**AGN Access Arrangement 2021
Capital Expenditure
Stage 2
Public**

**20 April 2021
Zincara P/L
11 Alexandra Street
St Kilda East 3183**

Figure 3-1: Cast iron failure history over time

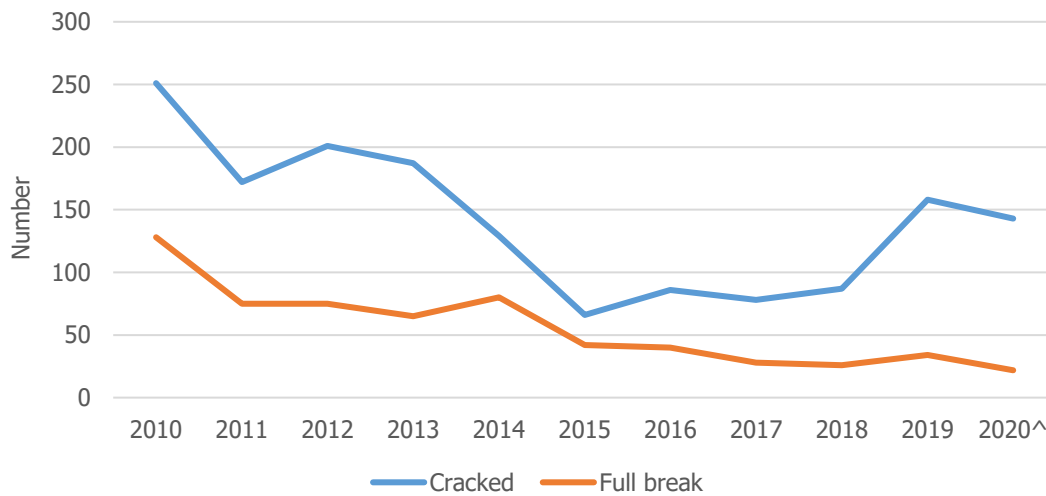
While the above figure shows that the mains replacement program has had a positive impact on the number of cast iron failures, there has been an increase in cracked mains in 2019, compared with previous four years. The updated data shows that the increased number of cracks have continued in 2020. By comparison, the number of full breaks have not reflected this trend.

Figure 3-2: Historic breaks and cracks on cast iron mains remaining in the network

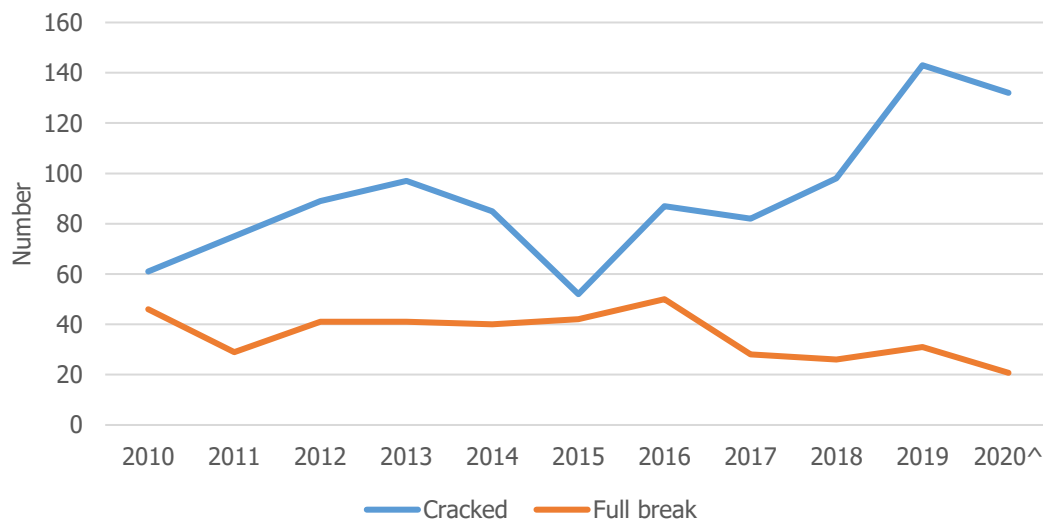
The following figure shows the breaks and cracks reported on remaining mains in the network, with data updated to include 2019 and 2020. As would be expected, the data generally reflects the failure history over time.

Figure 3-3: Cast iron mains leaks per km

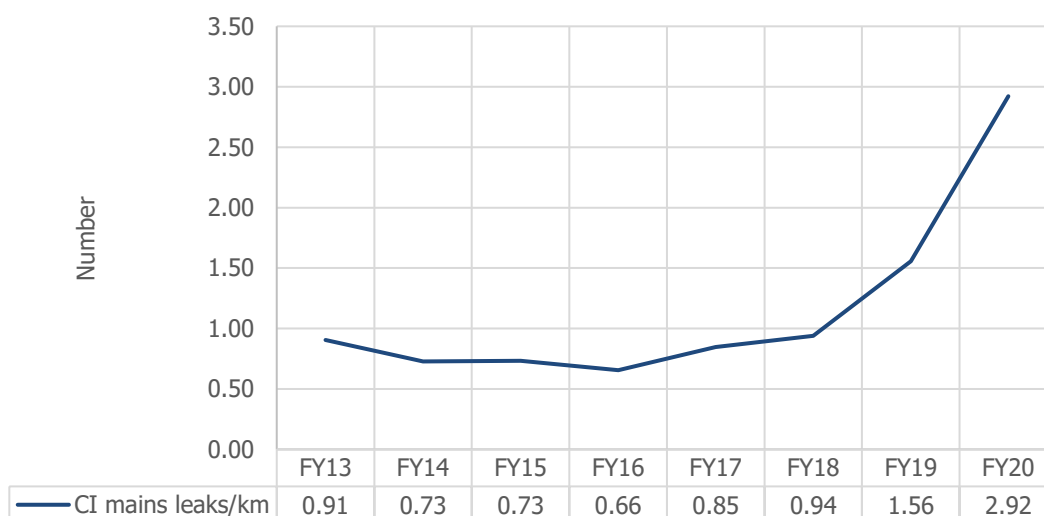
In its IR022 response, AGN also provided the following figure which shows total leaks on cast iron mains per kilometre each year, noting that around 60% of these leaks are attributable to joint leaks. There is an increased rate of leaks in 2019 and further increase in 2020.

AGN said² that the leaks data indicates that the rate of mains replacement during the current period is not sufficient to address the further deterioration of mains each year they remain in service.

Figure 3-4: HDPE 575 mains – squeeze off failure history by year laid and diameter

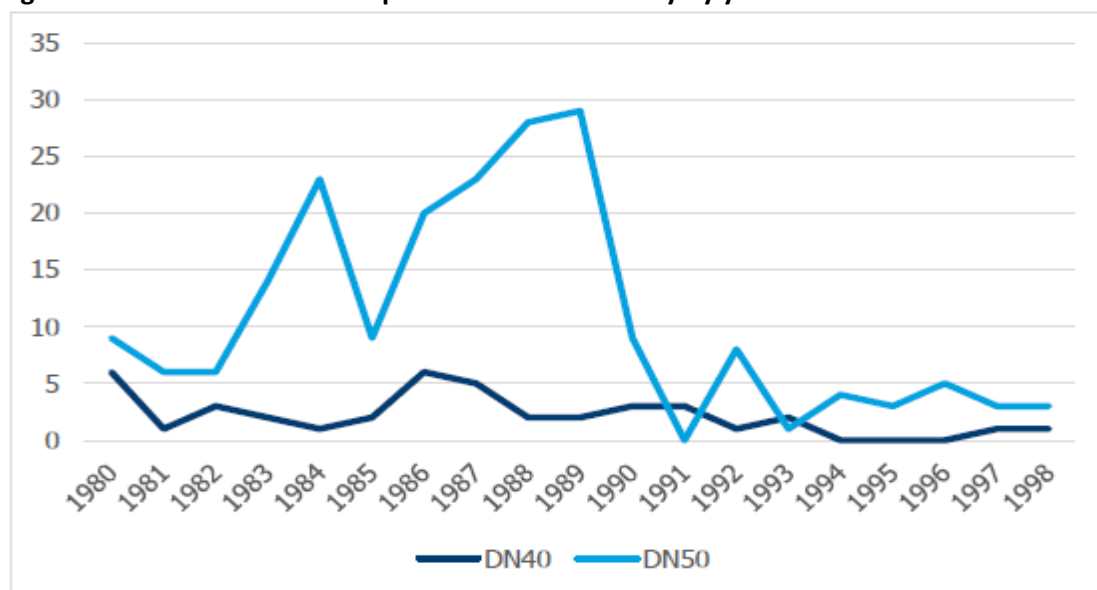
While the above figure shows a flattening of the curve from 1993, particularly for DN50 mains, it also shows that failures in DN40 mains are consistently lower DN50 mains. Data provided by AGN in IR004, shows failure rates per kilometre are typically lower for DN40 compared with DN50.

The additional information contained in the memo of August 1991 and likely confirmed in the Figure 3-4 above, do indicate that the improved squeeze-off practices from 1993 have been effective in significantly reducing the number of squeeze-off failures, particularly with respect to DN50 mains.

The data does show that there were some failures on DN40 HP mains during 1991 and 1992, reducing to almost zero from 1993.

In consideration of all of the information provided, and risk consequence of failure, we conclude that HDPE 575 DN40 HP mains laid up to 1993 may be subject to greater risk of structural damage associated with historic squeeze-off practices and it would therefore be prudent to undertake a prioritised mains replacement program during the next AA period. This recommendation increases the AER draft decision from 150 kilometres and capex of [REDACTED] million to 198 kilometres and capex of [REDACTED] million, an increase of 48 kilometres and capex of [REDACTED] million (2019/20 direct).
